MO MCI RNAV (RNP) Z RWY 9 AMDT 2

4-25-22 PRB Results: Returned for Rework

PRB RESULTS: RETURN FOR REWORK

RNAV (RNP) Z RWY 9

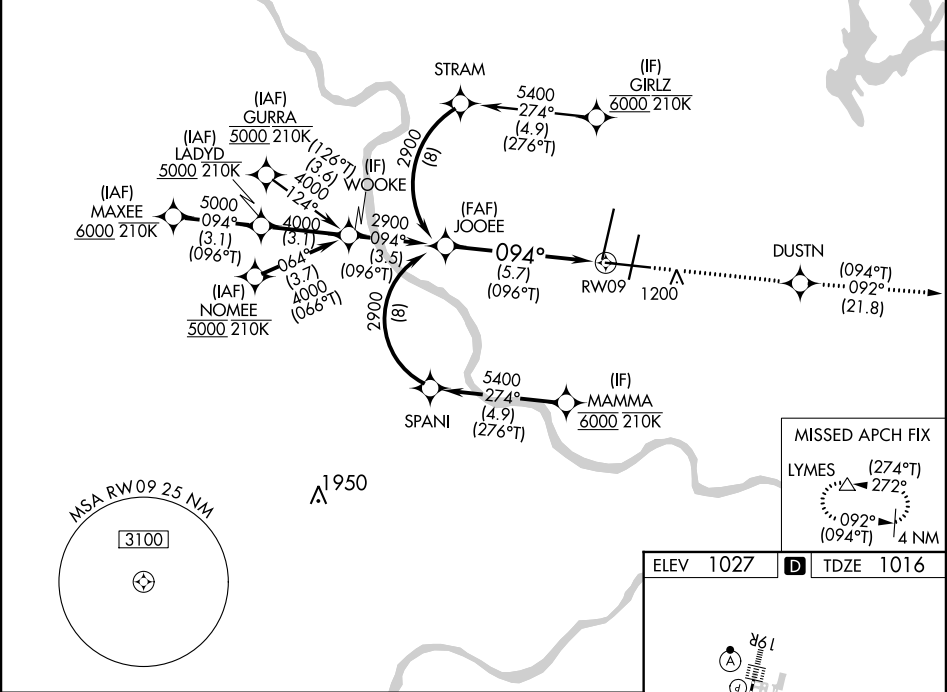
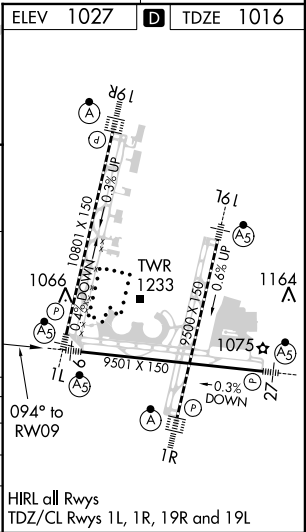
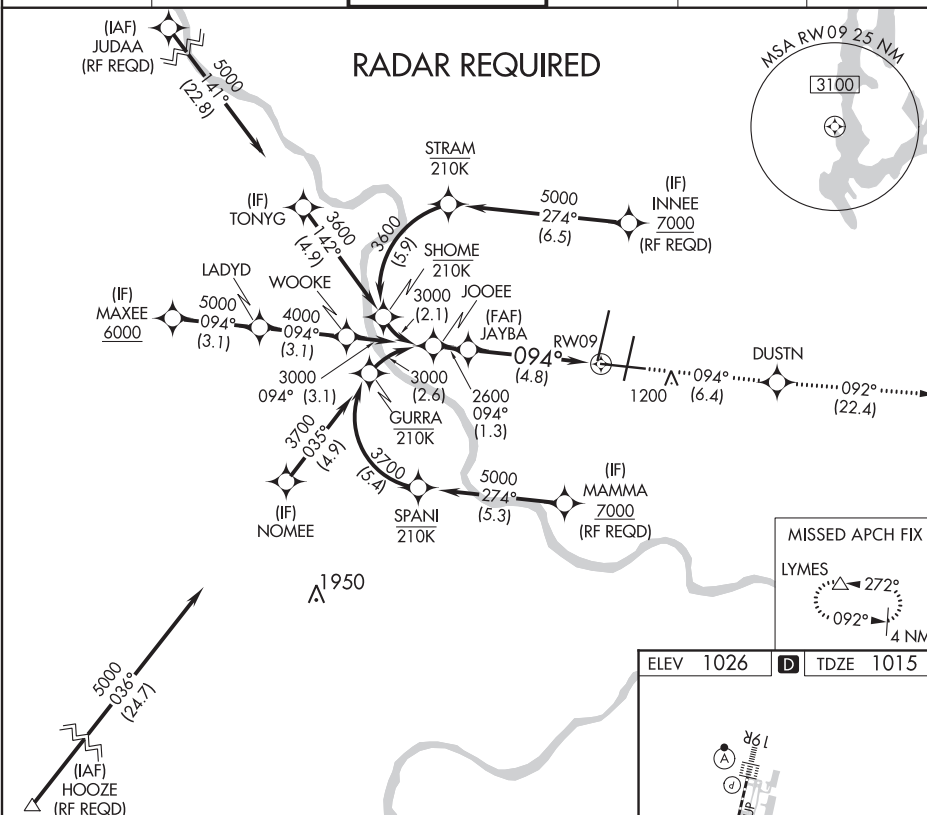
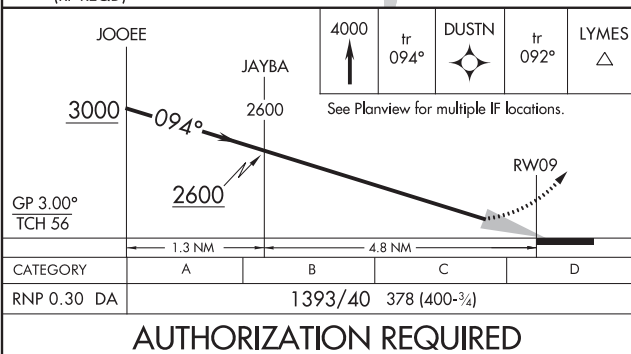
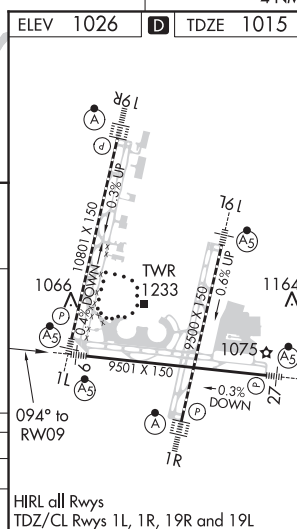
- APPROVAL LETTER: IAW 8260.3E, 2-2-7 ALTITUDES, F. STAR TERMINATION ALTITUDE, (1): AN ALTITUDE RESTRICTION MUST BE ESTABLISHED AT THE TERMINATION FIX OF THE STAR IF THE SAME FIX IS CHARTED ON AN APPROACH PROCEDURE. IF THE APPROACH PROCEDURE FIX HAS AN ALTITUDE RESTRICTION ASSOCIATED WITH IT, THEN THE STAR TERMINATION ALTITUDE RESTRICTION MUST BE IDENTICAL TO IT. FOR EXAMPLE, IF THE APPROACH PROCEDURE'S FIX IS A MANDATORY ALTITUDE, THEN THE STAR MUST END WITH AN IDENTICAL MANDATORY ALTITUDE. IF THE APPROACH PROCEDURE'S FIX IS A MINIMUM ALTITUDE, THEN THE STAR MUST END WITH AN IDENTICAL MINIMUM ALTITUDE.

- THIRD PARAGRAPH STATES: "...GIRLZ CONNECTS TO RUDDH ONE STAR WHICH IS PUBLISHED AT 6000 FT MSL AND 210K. MAMMA CONNECTS TO MHOMS ONE AT 6000 FT MSL AND 210K."

O GIRLZ LINES-UP WITH THE RUDDH ONE ARRIVAL AND THE ALTITUDE AND SPEED MATCH. MAMMA LINES UP WITH THE MHOMS ONE ARRIVAL AND INCLUDES THE SPEED RESTRICTION. HOWEVER, THE MHOMS ONE SHOWS MAMMA AT 7000. -MHOMS STAR FIG was incorrect and will show at 6000 to match the RNP procedure.

- ADDITIONAL WAIVER REQUIRED: IAW 8260.58B, PARA 1-3-1C: THE LEG LENGTH FROM NOMEET TO WOOKE (3.65), AND GURRA TO WOOKE (3.64) MUST BE AT LEAST 3.79 NM TO SUPPORT ATC VECTORS -Historical tailwinds (2016-2020 – 99th percentile) used for procedure development along with a speed restriction according to 8260.58 Table 1-2-2, maybe we can add a comment on the back of the 8260-9 or in the segment remark for future development.

O SAT FLIGHT CHECK PC Awaiting FC results.
